**Subject: Request for Approval of Class 1 Modification to the Los Alamos National Laboratory (LANL) Hazardous Waste Facility Permit, EPA ID # NM0890010515**

## Permit Modification Notification

### Permit Modification Summary

Attachment G.12 – TA-54 Area G Pad 11 Outdoor Closure Plan

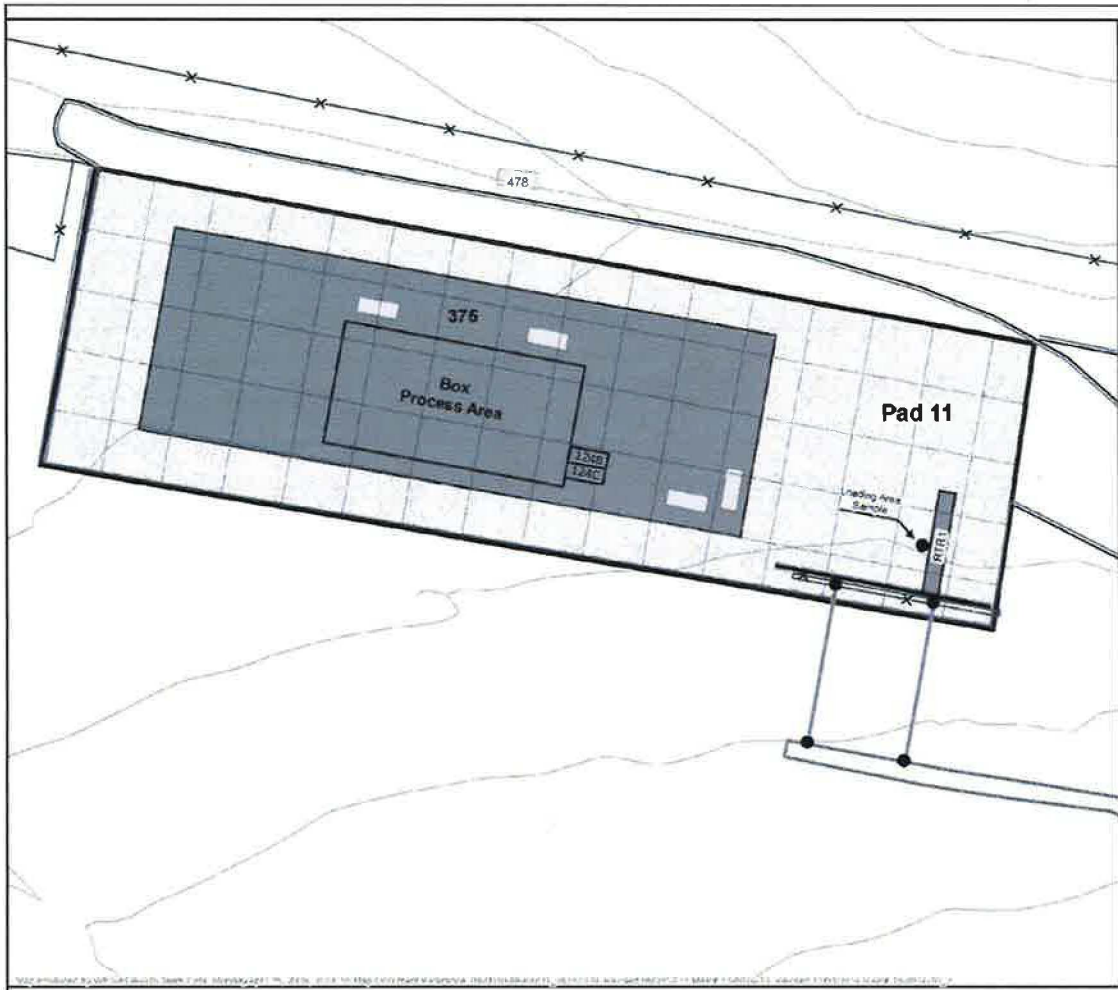
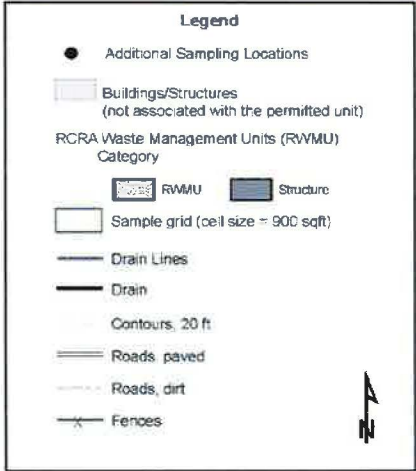
Figure 36, *TA-54, Area G, Pad 11* and Figure G.12, *Technical Area 54, Area G, Pad 11 Outdoor Closure Plan*, were revised to include the location of both the containerized freezer unit and the containerized refrigeration unit.
